Transformer for mixer heating
42V~/24VA

Mixer jar heating
with integrated temperature switch

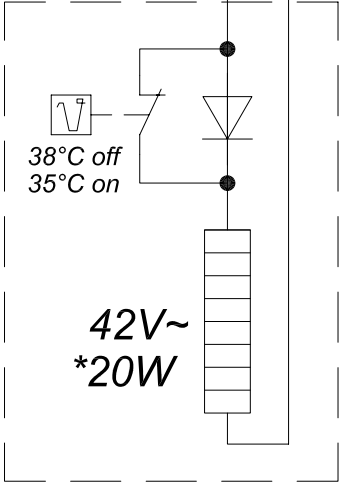
Always connect the transformer for this type of mixer heating to continuous phase 230V!
(Mixer heating with integrated temperature switch)

This indication takes priority if the terminal assignment deviates from the wiring diagram of the machine!

If necessary, ask for the updated wiring diagram of the machine.
